**The Peelle Company**

## **TECHNICAL BULLETIN**

### **PREVENTATIVE ACTION REQUIRED**

- SUBJECT:** LANDING DOOR INTERLOCKS, LANDING DOOR LOCK AND CONTACTS AND NEMA 4/4X/7 GATE CONTACTS.
- EQUIPMENT:** PEELLE INTERLOCK/LOCK AND CONTACT PART NUMBERS 2356, 2356-59, 2356-67, 2332, 2332-32, 2332-29, 2344, 2344-32, 2344-29, 2352, 2352-52, 23526 AND PEELLE GATE CONTACT PART NUMBERS 2376, 2377 & 0320.

033171 CONTACT SPRING

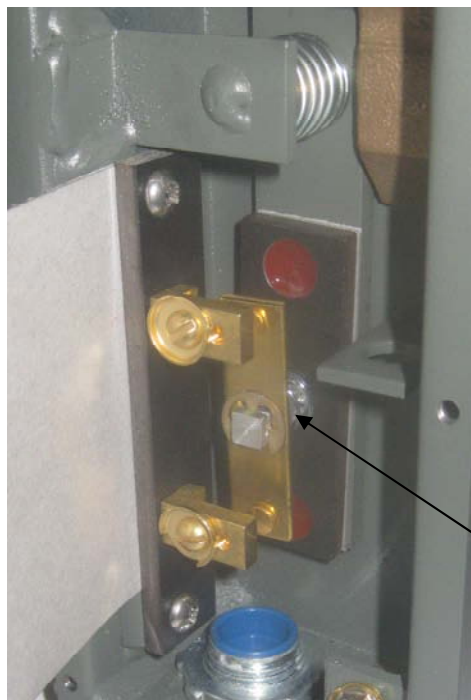
- DESCRIPTION:** WHEN THE CONTACT BAR USED FOR THE DC (DOOR CLOSED) CONTACT OR GC (GATE CLOSED) CONTACT HAS BEEN CHANGED OR MAINTAINED, THE WRONG SPRING OR A DAMAGED SPRING COULD BE USED IN RE-ASSEMBLY. THIS IS A POSSIBLE SAFETY CONCERN.

- ACTION:** IT IS ESSENTIAL THAT WHEN MAINTAINING THE DC/GC CONTACT, A NEW 033171 CONTACT SPRING SHOULD BE USED. PLEASE SEE SKETCH BELOW FOR PROPER SPRING SPECIFICATIONS. PLEASE CONTACT TANIA BUTLER AT (905)846-4545 x218 IF YOU REQUIRE REPLACEMENT PARTS.
